Project Name: Sunset Grove

Location: Located on Mt. Gilead Church Rd, Chatham County

Subject Stream: Refer to Sheet 5 of buffer review packet: Timmons Group Figure 4: Preliminary Jurisdictional Waters of The U.S. Delineations Map

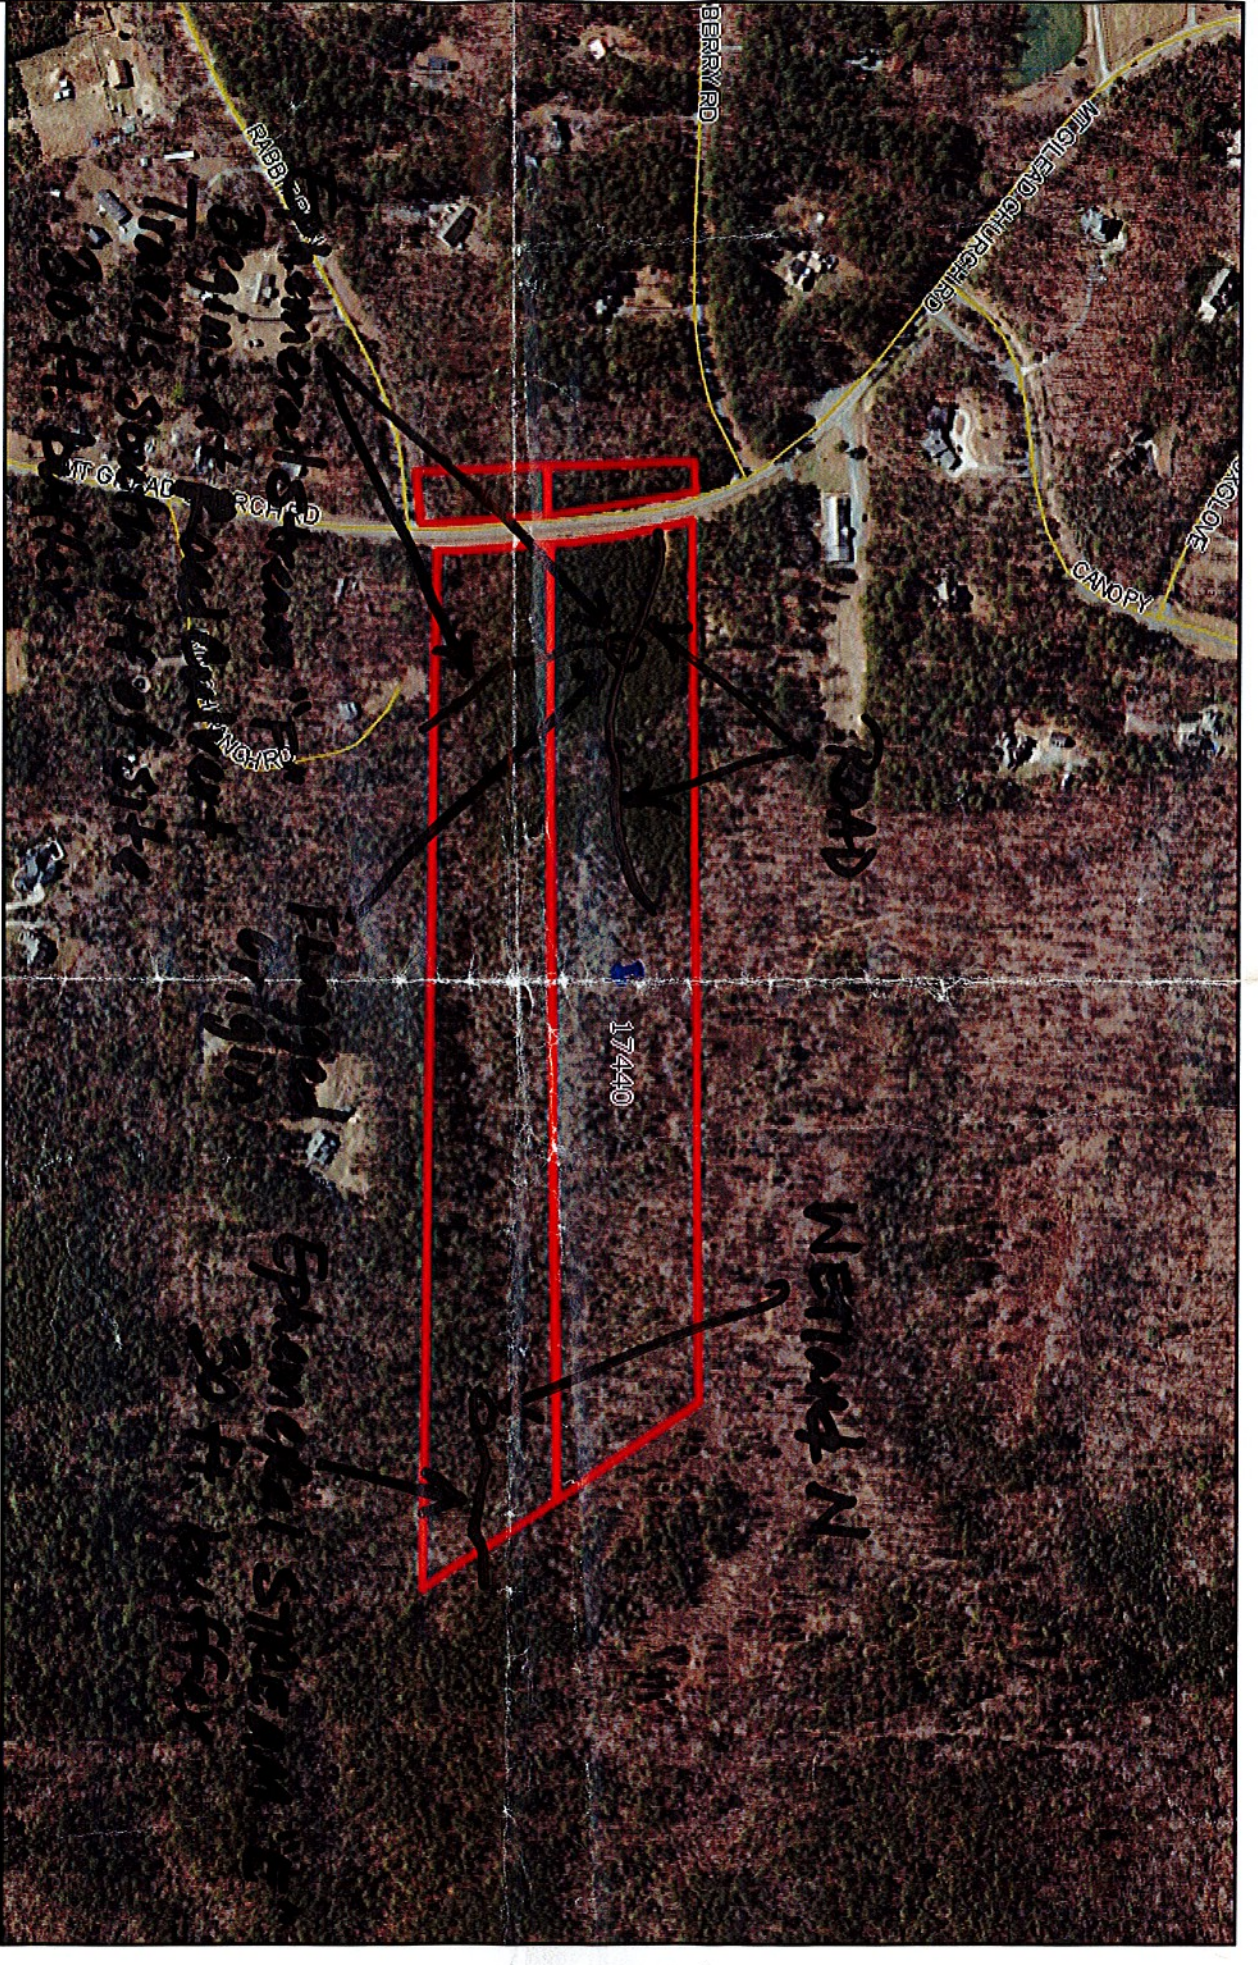
Chatham County staff conducted a field visit on 10/14/15 to verify stream origins and is issuing this preliminary stream determination. The origin of Intermittent stream (F), on Timmons Groups exhibit will need to be updated to an origin located at a culvert under the current main access road leading into the site, and changed to Ephemeral. Ephemeral Stream (E) was verified to be true with Timmons groups original findings: its location and stream scoring. Both stream E & F will require a 30 foot ephemeral buffer per Chatham County stream buffer rules and regulations.

Findings: Stream F on Timmons Group preliminary TD waters map is ephemeral, with its origin located at a culvert pipe under gravel main drive. Stream E on preliminary map is also ephemeral. Both streams will require a 30 foot buffer.

STREAM (F)

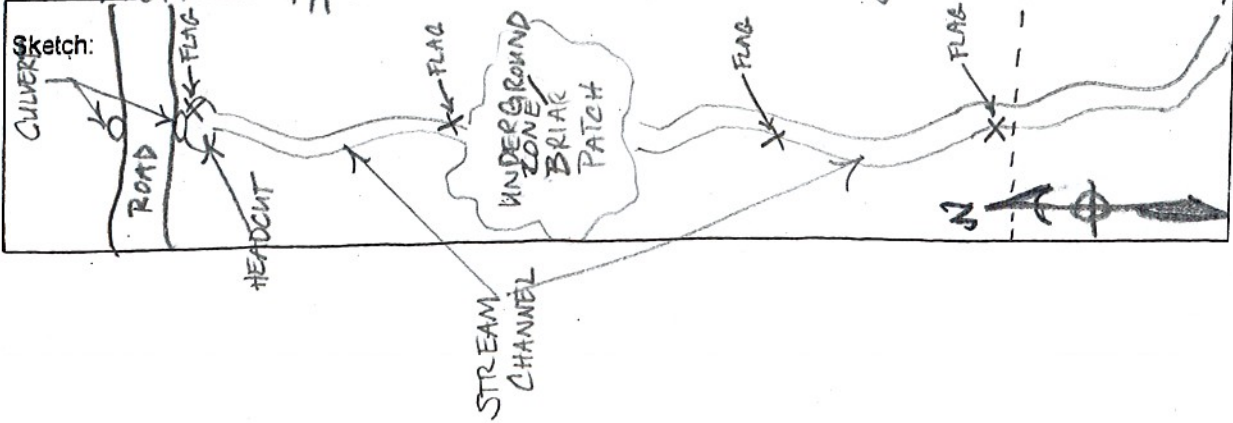
Date: 10/14/15	Project/Site: SUNSET GROVE	Latitude:
Evaluator: S. Pickens	County: Chatham	Longitude:
Total Points: Stream is at least intermittent if ≥ 19 or perennial if ≥ 30 17	Stream Determination (circle one) Ephemeral Intermittent Perennial	Other e.g. Quad Name:

Notes: Channel begins at Culvert pipe, moves under ground through wetland-type area and re-channelizes just after Briar Patch.

STREAM (E)

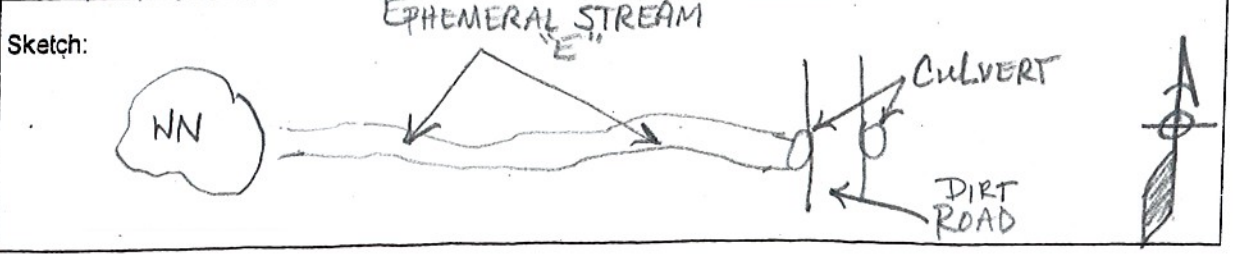
Date: 10/14/15	Project/Site: SUNSET GROVE	Latitude:
Evaluator: S. Pickins	County: Chatham Co.	Longitude:
Total Points: 110 <i>Stream is at least intermittent if ≥ 19 or perennial if ≥ 30*</i>	Stream Determination (circle one) Ephemeral Intermittent Perennial	Other e.g. Quad Name:

Notes: Drainage from wetland "N" forms channel ephemeral channel to the east.
